New SU Fuel Pump Fittings Using ‘O’ Ring Seals by David DuBois

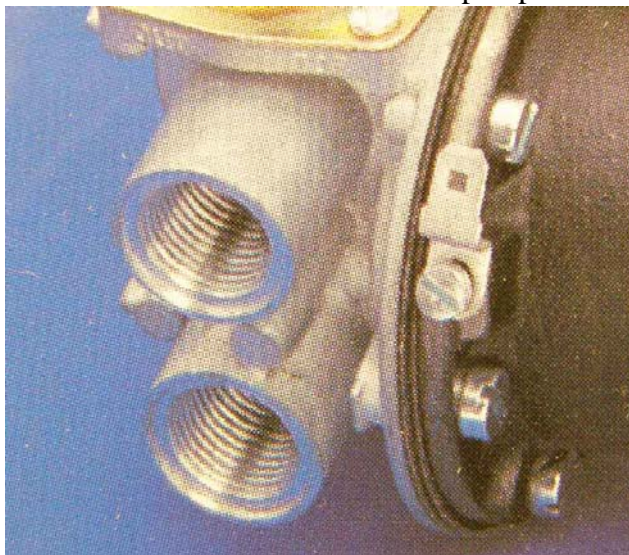
The new AZX 1300 series, AZX 1400 series, AZX 1500 series SU fuel pumps are now using an ‘O’ ring between the ports of the pump and the banjo fitting (see pictures below). If your pump has a recessed area on the inlet and outlet ports, you need an ‘O’ ring at that point instead of a fiber washer that was used on the earlier pumps

The order of assembly for the banjo fitting on these new pumps is as follows: Fit the ‘O’ ring into the recessed area of the pump’s inlet and outlet ports (Note: fitting one of the old standard fiber washers into this area will cause the fitting to leak), the banjo fitting goes on top of the ‘O’ ring with the flat surface against the ‘O’ ring, a standard fiber washer goes into the recessed area on the top of the banjo fitting, and finally the banjo bolt is inserted through the fitting, into the port and is tightened until the fitting is good and snug against the port.

Unfortunately, the new pumps are not shipped with new ‘O’ rings so it is necessary to purchase them yourself. The Moss P/N is 370-655, Burlen Fuel Systems P/N is AUB 654, the standard Parker ‘O’ ring P/N is 2-017 (usually available from NAPA) and the dimensions of the ‘O’ ring (for those who are unable to find them any other way) are:

ID – 0.680”, W (thickness of the rubber) – 0.007”.
